DEPARTMENT OF THE INTERIOR**Bureau of Land Management****43 CFR Parts 3160 and 3170**

**Onshore Oil and Gas Operations;
Federal and Indian Oil and Gas Leases;
Measurement of Gas****AGENCY:** Bureau of Land Management, Interior.**ACTION:** Final rule.

SUMMARY: This final rule updates and replaces Onshore Oil and Gas Order No. 5 (Order 5) with a new regulation codified in the Code of Federal Regulations (CFR). Like Order 5, this rule establishes minimum standards for accurate measurement and proper reporting of all gas removed or sold from Federal and Indian (except the Osage Tribe) leases, units, unit participating areas (PAs), and areas subject to communitization agreements (CAs). It provides a system for production accountability by operators, lessees, purchasers, and transporters. This rule establishes overall gas measurement performance standards and includes, among other things, requirements for the hardware and software related to gas metering equipment and reporting and recordkeeping. This rule also identifies certain specific acts of noncompliance that may result in an immediate assessment and provides a process for the Bureau of Land Management (BLM) to consider variances

Figure 2

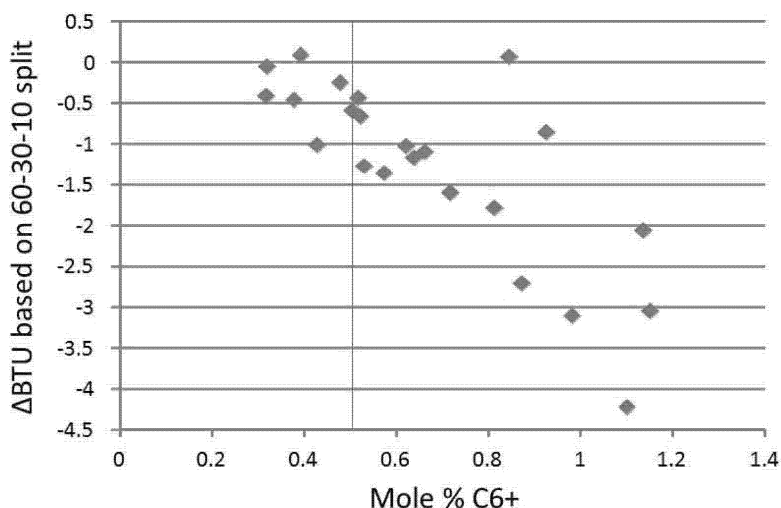
One commenter indicated that the difference in heating value between a C₆₊ analysis and an extended analysis is less than the accuracy of the GC, and therefore, is not significant. Several commenters submitted data showing the difference in heating value based on a C₆₊ analysis and an extended analysis. The BLM analyzed these data and generated a graph showing the difference in heating value between a C₆₊ analysis and an extended analysis as a function of the mole percentage of C₆₊, assuming a 60–30–10 split of hexane, heptane, and octane, respectively (Figure 2).

The BLM does not believe that Figure 2, generated from the data supplied by the commenters, supports the commenter’s conclusions that the difference between an extended analysis and a C₆₊ analysis is less than the accuracy of a GC and is not significant or necessary. To analyze these data, the BLM first determined whether the apparent bias in the data as the mole

points. From Figure 2, there are three points that fall outside of the ± 2.8 Btu/scf threshold at the bottom right-hand part of the graph. These three points include three of the four highest mole percentages of C₆₊ included in the data (1.0, 1.1, and 1.15 mole percent C₆₊). As a result, the BLM concludes that the data presented by the commenters indicates a statistically significant bias associated with the assumed 60–30–10 split of C₆₊ when the mole percent of C₆₊ is 1.0 mole percent or higher. Therefore, the BLM disagrees with the comment that the difference in heating value between a C₆₊ analysis and an extended analysis is less than the accuracy of the GC, and therefore it is not significant. The BLM did not make any changes to the rule based on these comments.

Commenters also made various suggestions regarding extended analysis that included not requiring an extended analysis in any circumstance and adjusting the C₆₊ threshold for requiring an extended analysis to a higher percentage (suggested values ranged from 0.5 mole percent to 1.0 mole percent). The BLM agrees with the comments suggesting a different threshold and changed the threshold at which an extended analysis is required from 0.25 mole percent in the proposed rule to 0.50 mole percent in the final rule. Not only does Figure 2 show a bias in the heating value when the mole

percent of C₆₊ exceeds 1.0 mole percent (assuming a C₆₊ split of 60–30–10 hexane, heptane, and octane, respectively), Figure 2 also suggests a correlation (correlation coefficient of 0.61) between the concentration of C₆₊ and heating value.

The BLM notes that Figure 2 is based on one data set that contains a fairly narrow range of heating values (1,086 Btu/scf to 1,181 Btu/scf) and, as such, may not be representative of potential bias or correlations that exist outside of that heating value range. Based on the threshold of significance analysis describe above, the BLM agrees that the 0.25 mole percent threshold from the proposed rule is too low and most likely would be less than the uncertainty of most GCs. However, the BLM believes that a threshold of 1 mole percent of C₆₊ is too high because the evidence supplied by one of the commenters (Figure 2) demonstrates that statistically significant bias is already present when the mole percent of C₆₊ reaches 1 percent. As a result, the BLM raised the threshold to 0.5 mole percent of C₆₊, which is one of the thresholds suggested by a commenter. The BLM believes that the 0.5 mole-percent threshold is a reasonable balance between ensuring that heating values are not biased and reducing the economic burden to operators associated with the 0.25 mole percent threshold in the proposed rule.
